Data Setting Location Change

Mobile IP Address and the Subscriber IP Address Reprogramming Required

Date Issued: 1/29/13

FSB-0113-ESDATA-01

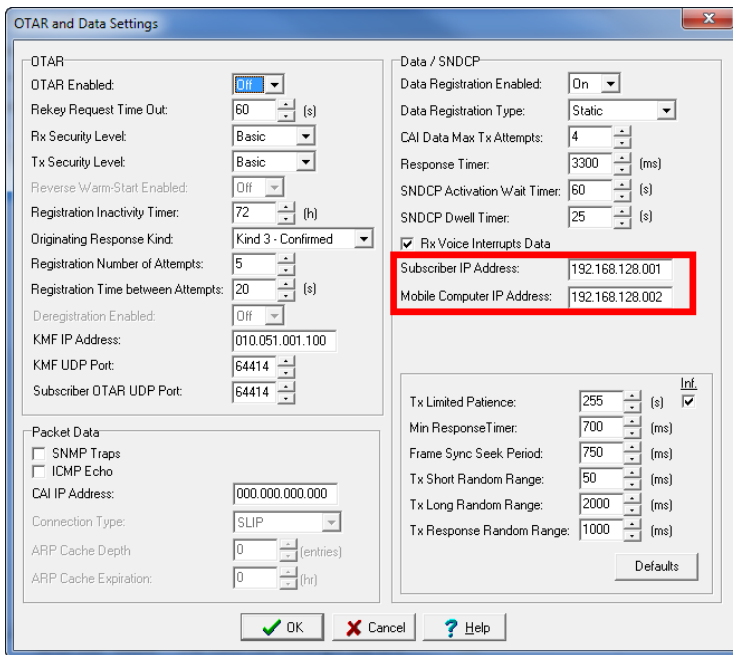
1. PC Configure versions prior to 2.14.5 had the Mobile IP Address and the Subscriber IP Address located on second page of the Per System Tab>OTAR and Data>Edit Settings.

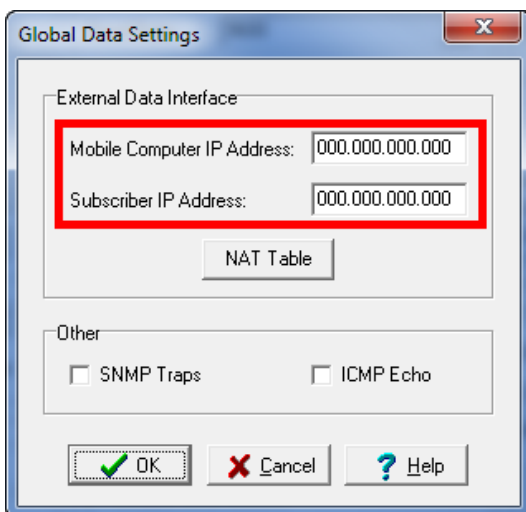
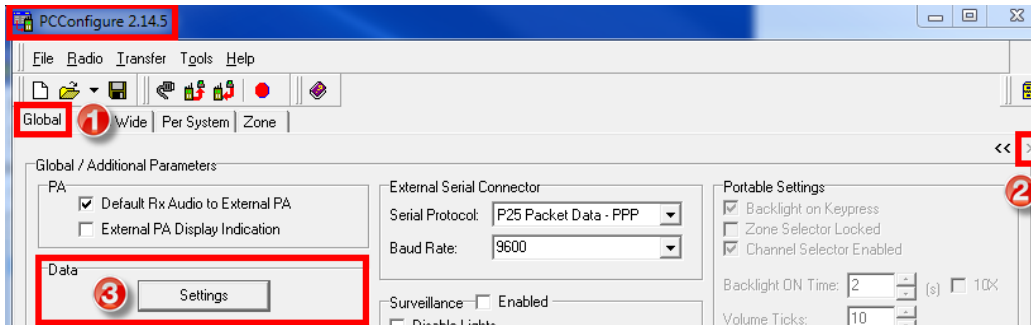
- After software updating a radio to a newer version of firmware that requires PC Configure 2.14.5 or higher the Mobile Computer IP Address and the Subscriber IP Address are now located on the second page of the Global Tab>Data>Settings and must be reprogrammed.
